SERVICE BULLETIN #278

Replacement/upgrade for motor mount bracket on Turbo-Seal® Insulated Gen2 doors

Date: 08/01/18

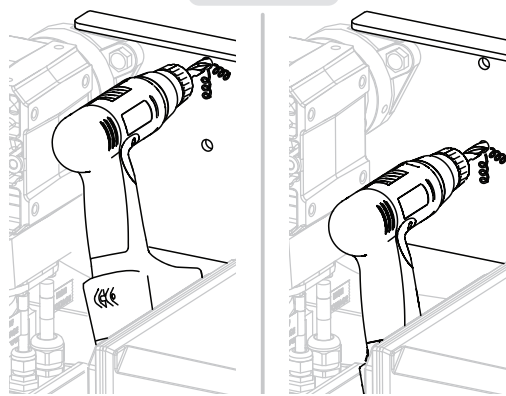
Drill out threaded holes.

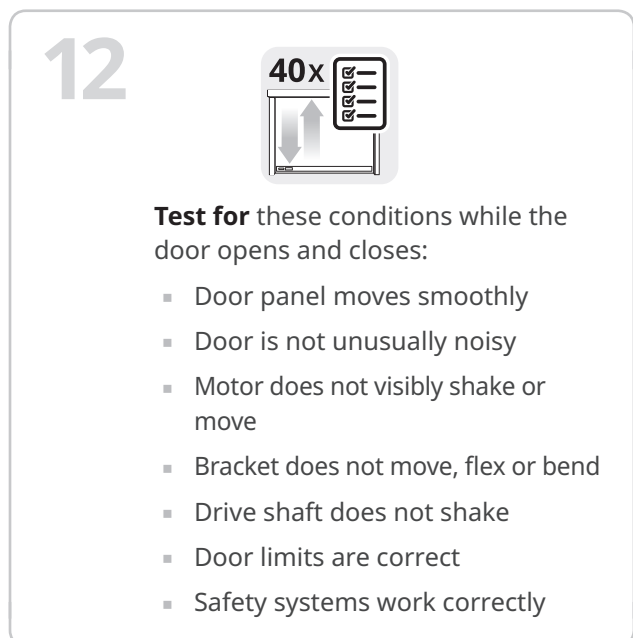
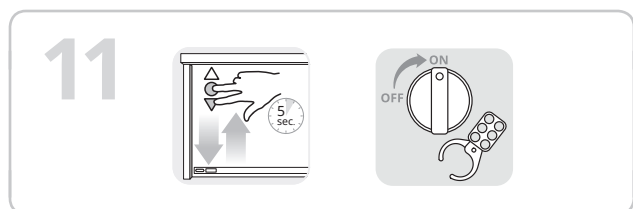
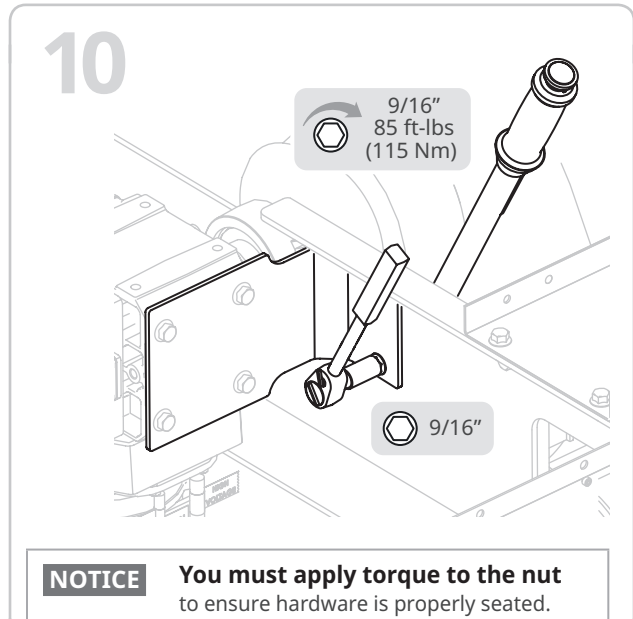
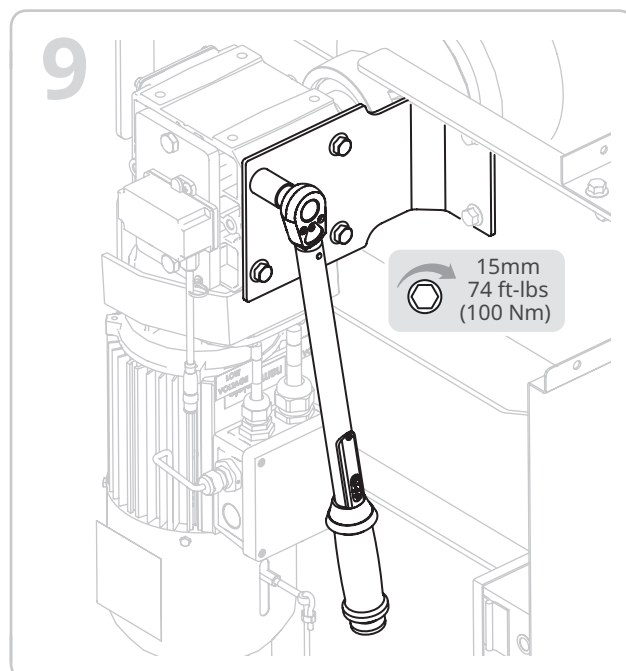
- 8** **Make sure** the motor mount bracket is flush to the motor and to the side plate. **Loosen** screws or nuts and reposition if necessary.

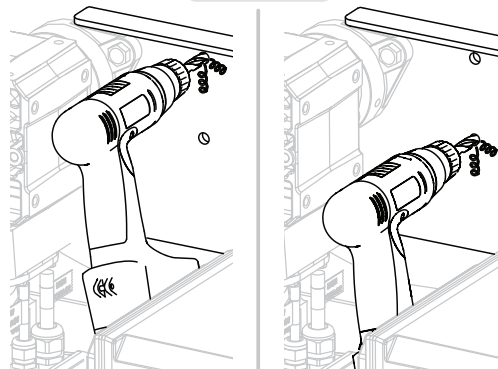
Drill out threaded holes.

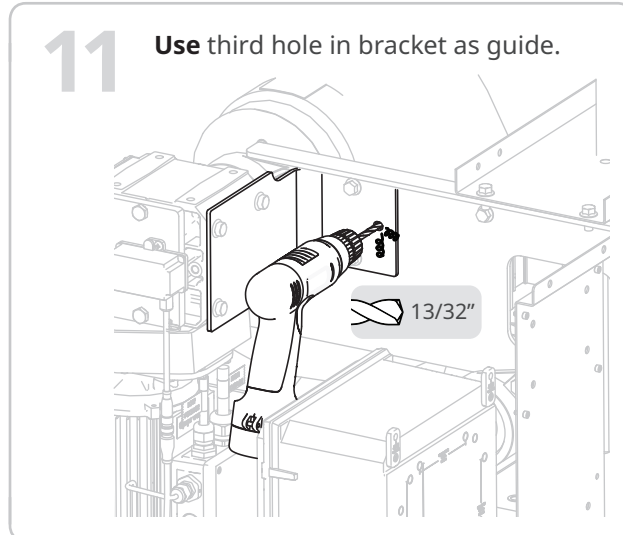
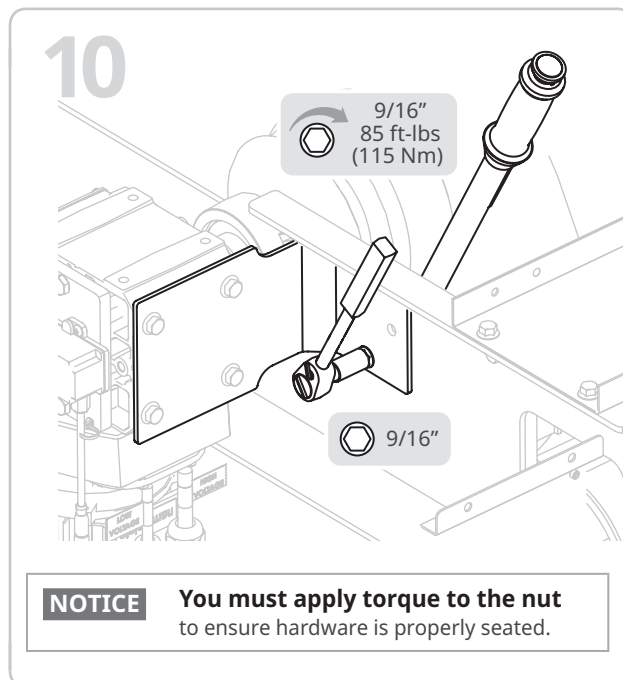
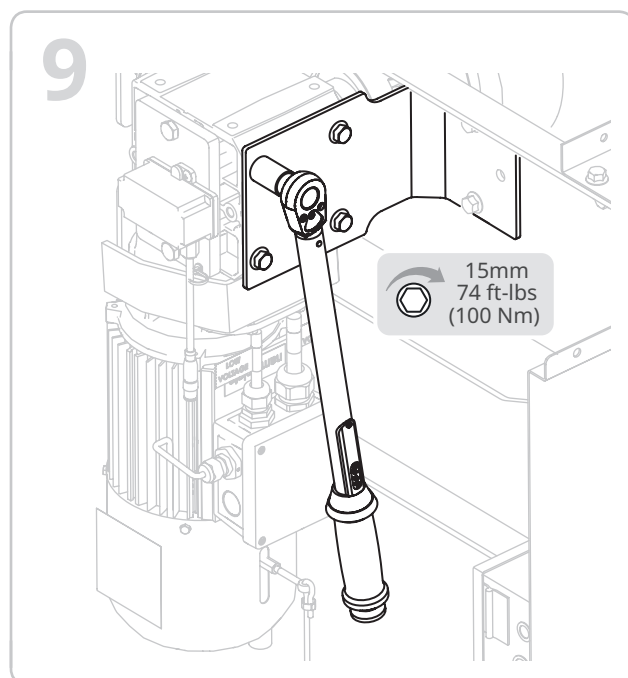
8 **Make sure** the motor mount bracket is flush to the motor and to the side plate. **Loosen** screws or nuts and reposition if necessary.
